TEXAS COMMISSION ON ENVIRONMENTAL QUALITY

AGENDA ITEM REQUEST

CAPTION: Docket No. 2012-1722-RUL. Consideration for publication of, and hearing on, proposed repeal of Sections 217.1, 217.36, 217.63, 217.69, 217.70, 217.94, 217.162, and 217.193; new Sections 217.1, 217.18, 217.36, 217.40, 217.63, 217.69 - 217.71, 217.90, 217.94, 217.120, 217.162, 217.193, and 217.194; and amended Sections 217.2 - 217.17, 217.31 - 217.35, 217.37 - 217.39, 217.51 - 217.62, 217.64 - 217.68, 217.91 - 217.100, 217.121 - 217.129, 217.151 - 217.161, 217.163, 217.164, 217.182 - 217.192, 217.201 - 217.213, 217.241 - 217.252, 217.271 - 217.283, 217.291 - 217.300, 217.321 - 217.330, 217.332, and 217.333 of 30 TAC Chapter 217, Design Criteria for Domestic Wastewater Systems.

Subject: Commission Approval for Proposed Rulemaking
Chapter 217, Design Criteria for Domestic Wastewater Systems
Amendment to Chapter 217: Design Criteria
Rule Project No. 2012-040-217-OW

Figure: 30 TAC §217.278(c)(3)

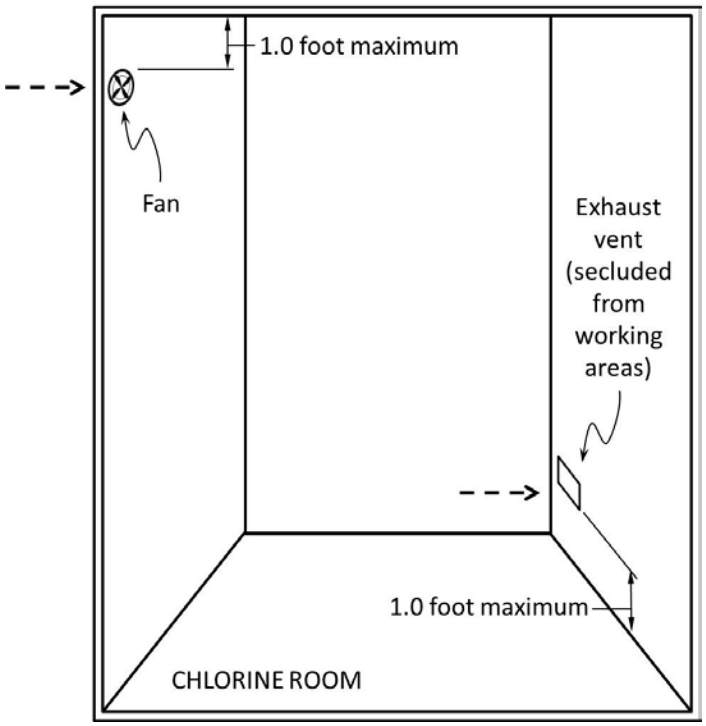
(3) A fan must be located at the top of the room to push air across the room and through an exhaust vent located at the bottom of the room on the opposite side (see Figure: 30 TAC §217.278(c)(3)). The top of the fan must be no more than one foot below the ceiling. The bottom of the exhaust vent must be no more than one foot above floor level.
